**BEFORE THE FAST TRACK APPROVALS EXPERT CONSENTING PANEL**

**IN THE MATTER**                      **of Delmore (residential subdivision and roading  
interchange at Orewa) – Second Application**

**STATEMENT OF EVIDENCE OF MITCHELL LOGAN ROBERTS FOR**

**(CIVIL ENGINEERING)**

Figure 1 - Extract from Auckland Transport's Memorandum highlighting the requested road connection locations.

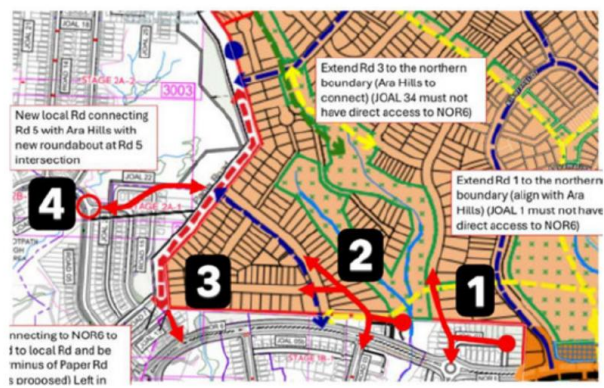
- 4.1 In Appendix 9.1 Vineway identify a number of connections between the AVJ site and the Delmore site, numbering them 1-4, as set out below. I agree with AT's rationale for seeking these connections.

- 4.2 I agree that there are some difficulties in making a connection at the location marked "2", but it is nevertheless an important connection into the AVJ site.
- 4.3 The identified difficulties in location 2 relate to height differences, gradient and earthworks cut / fill balance. These issues can be addressed by moving location 2 further eastward as the proposed and existing ground levels are closer across both sites at that point. Some transportation engineering matters may subsequently arise, and a roundabout might be needed, but these are matters which I believe should be able to be worked through to achieve an appropriate roading network. Potentially one lot might need to be relocated, depending on AT's requirements for the relevant intersection.
